RAMP REPORT REGION 2 ADA 2026

Lawerence St., & Ingraham Lane,
Rockland

CR04136

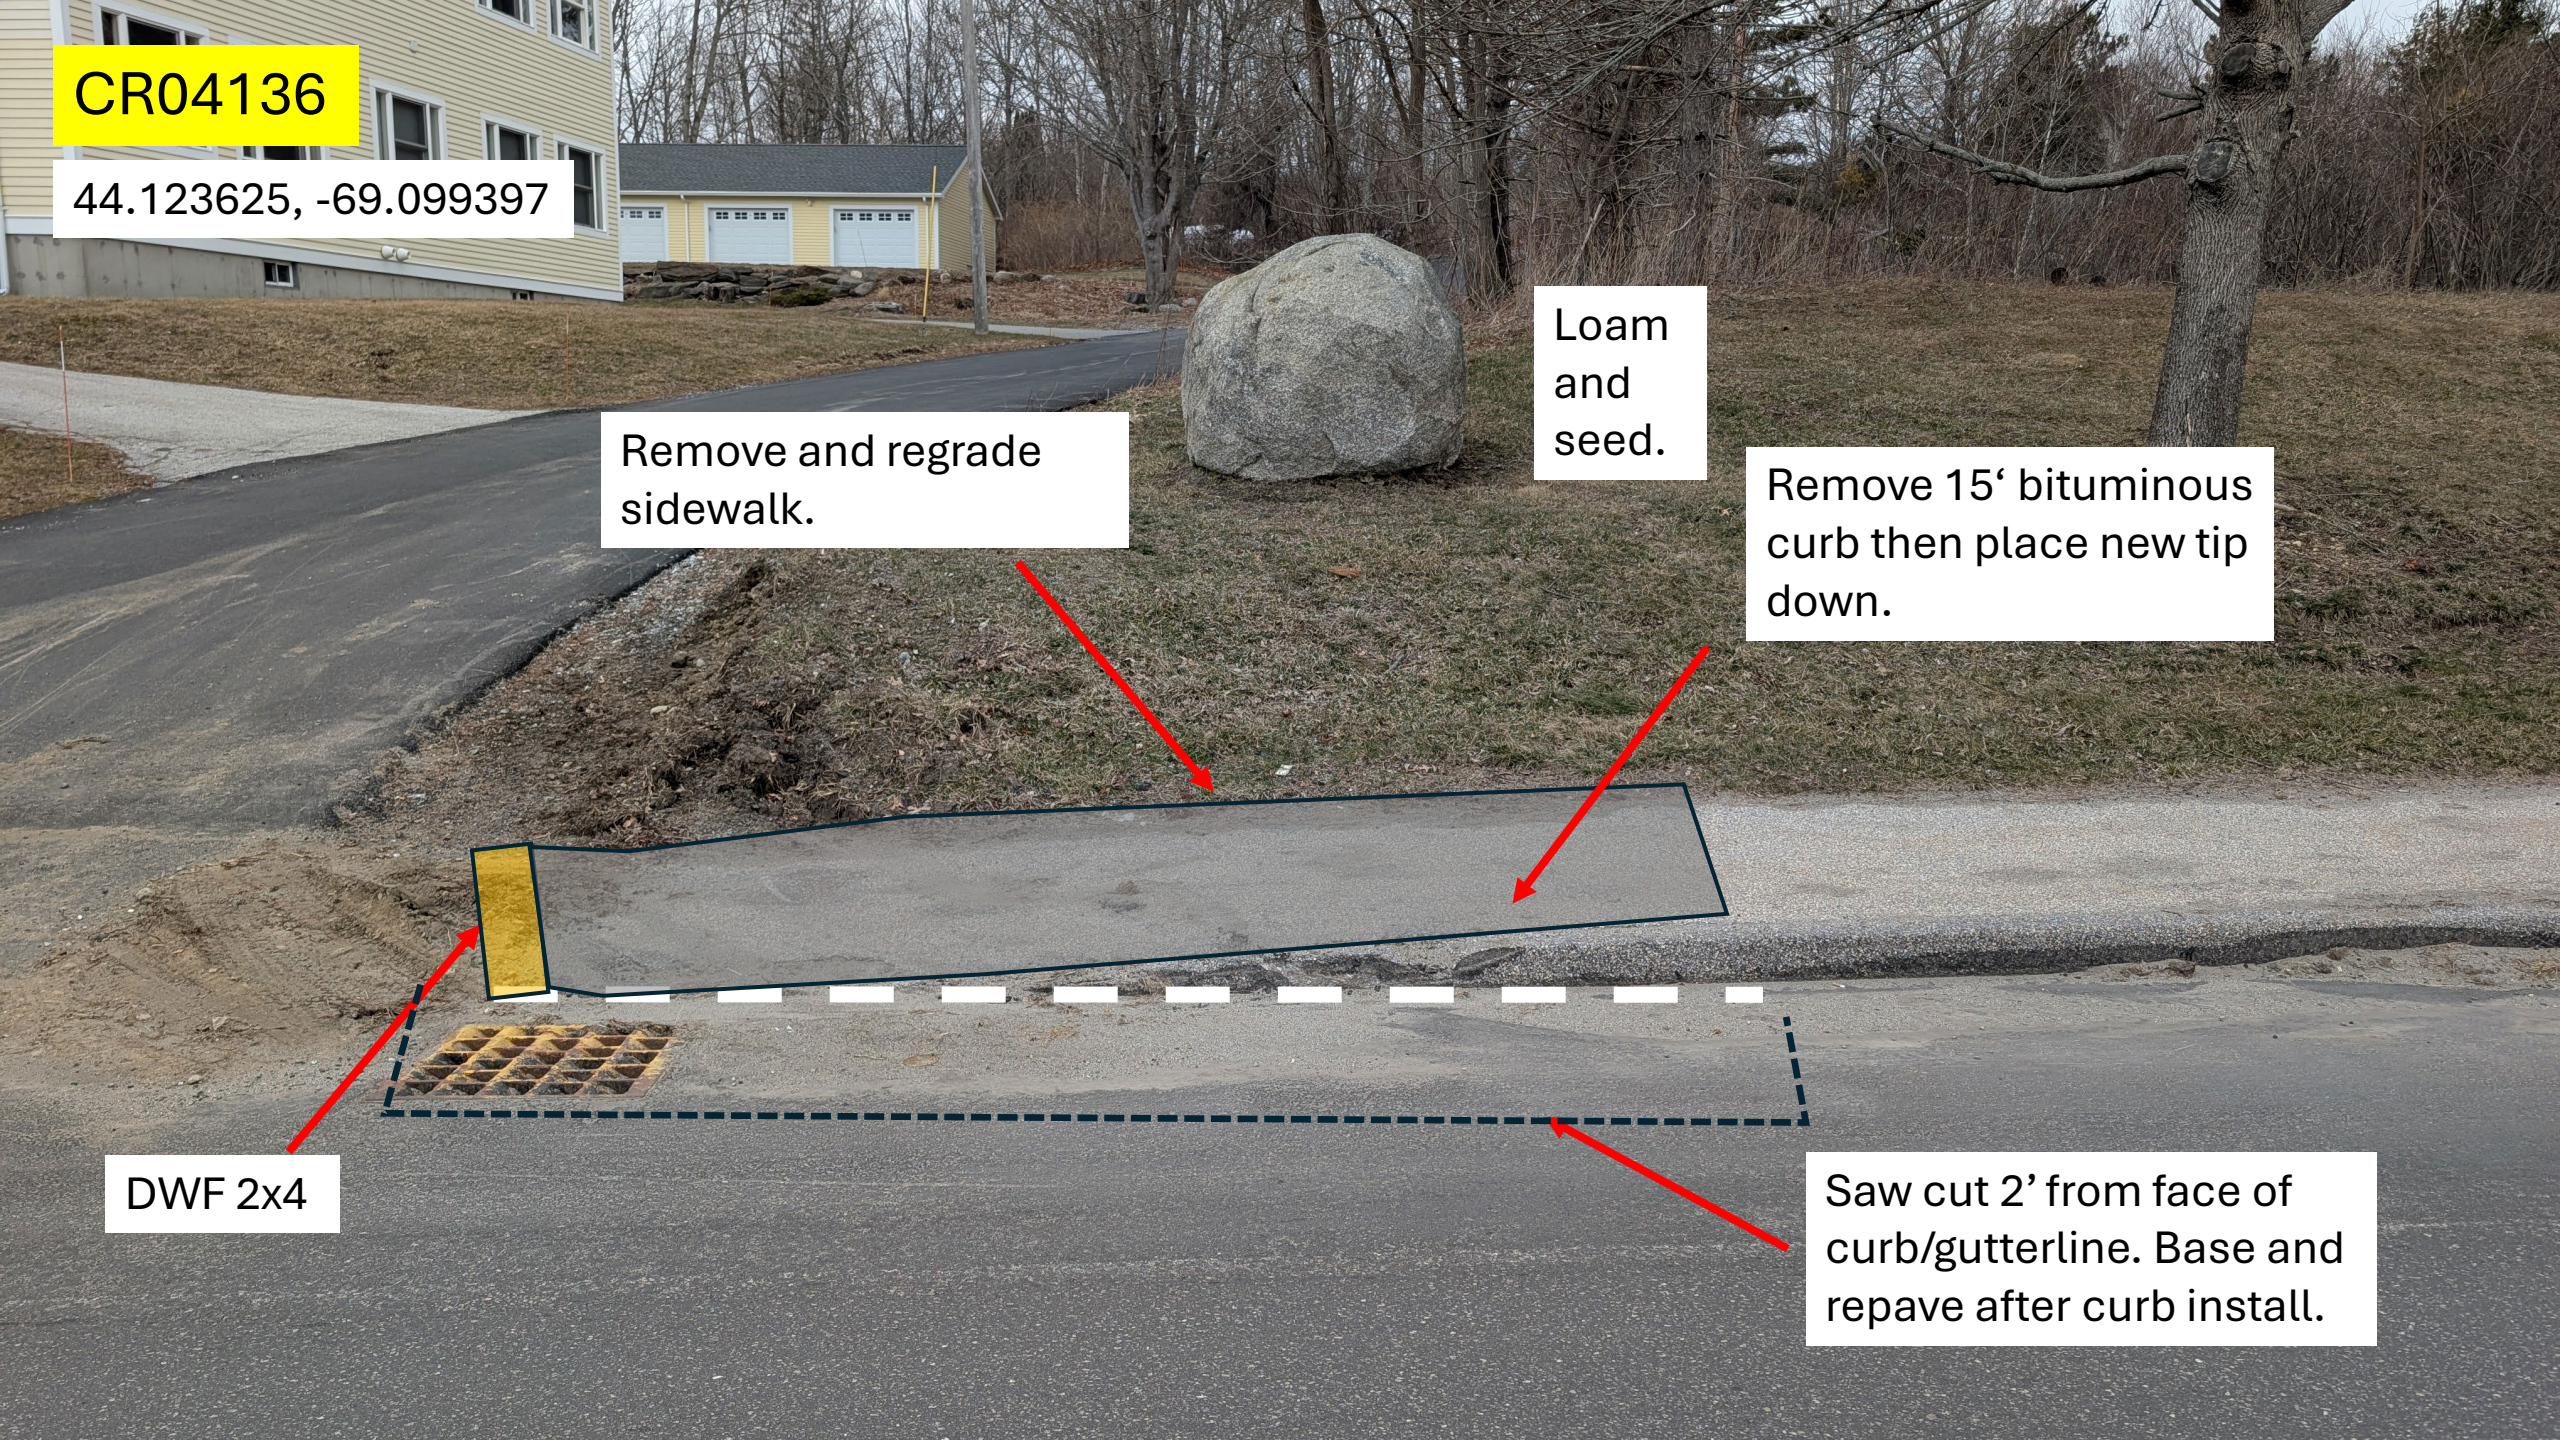
Remove and regrade
sidewalk.

Loam
and
seed.

Remove 15' bituminous
curb then place new tip
down.

DWF 2x4

Saw cut 2' from face of
curb/gutterline. Base and
repave after curb install.

CR16757

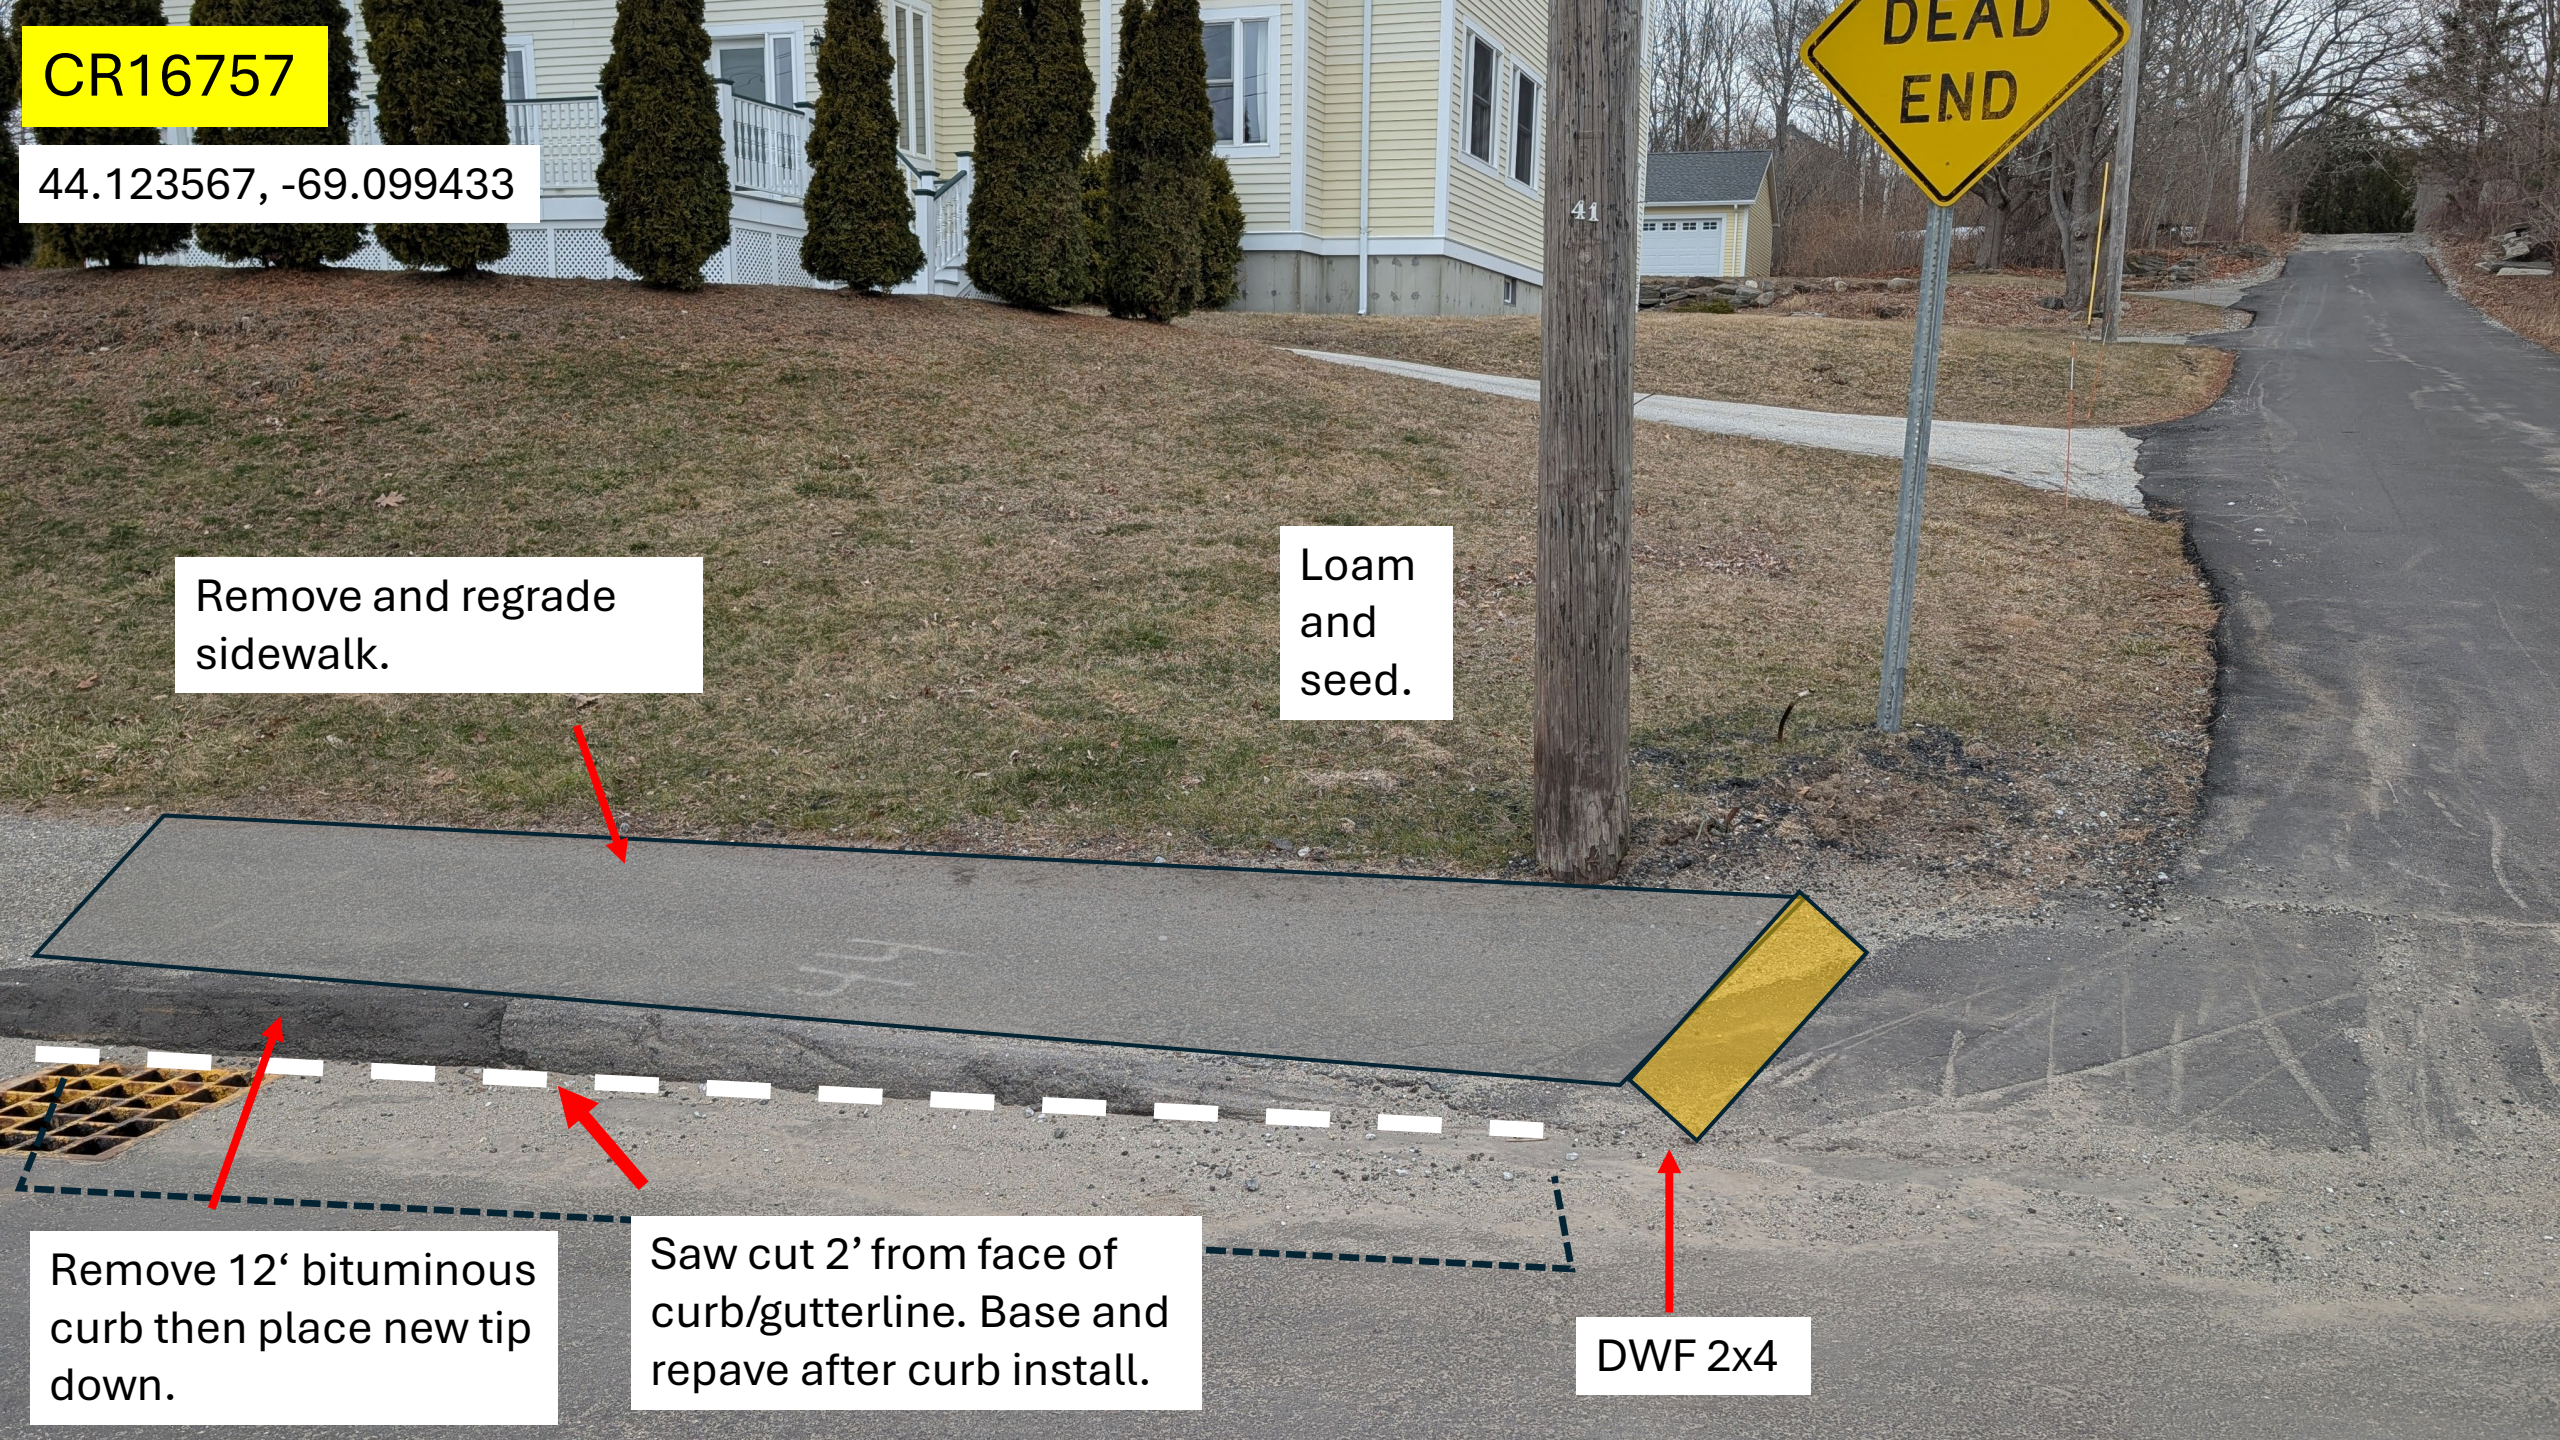
Remove and regrade sidewalk.

Loam and seed.

Remove 12' bituminous curb then place new tip down.

Saw cut 2' from face of curb/gutterline. Base and repave after curb install.

DWF 2x4

CR16761

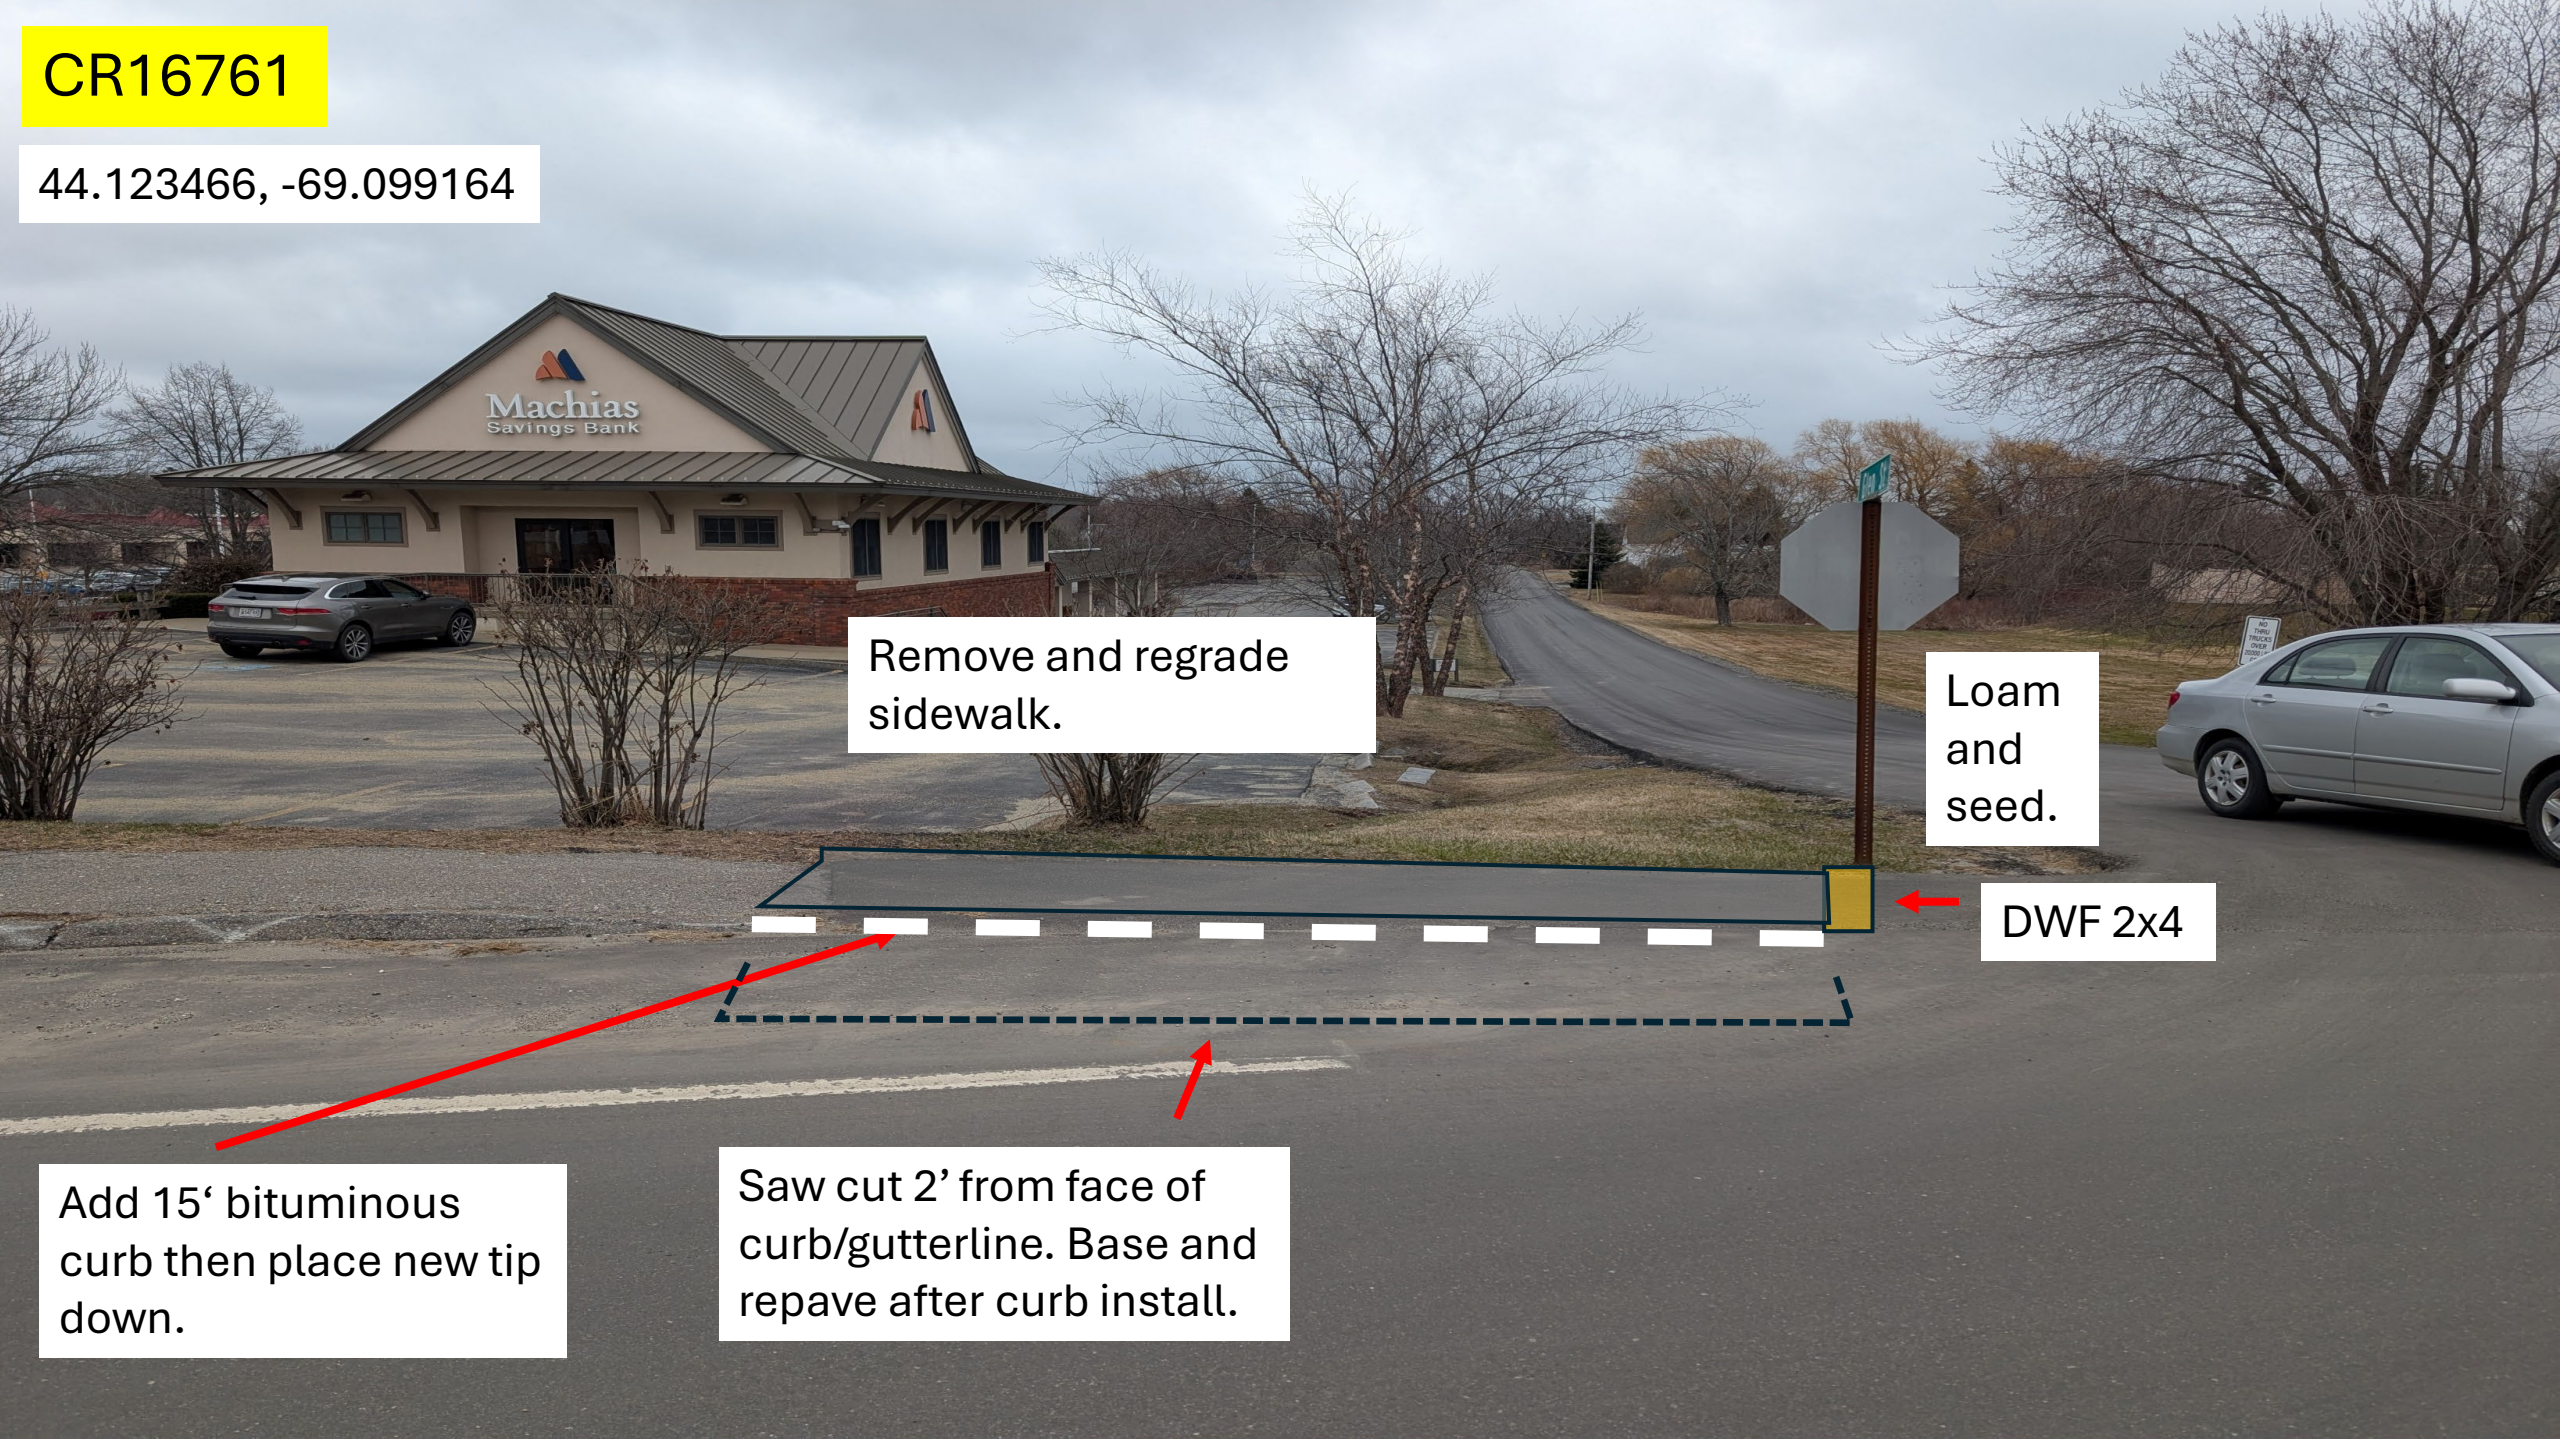
Remove and regrade sidewalk.

Loam and seed.

DWF 2x4

Add 15' bituminous curb then place new tip down.

Saw cut 2' from face of curb/gutterline. Base and repave after curb install.
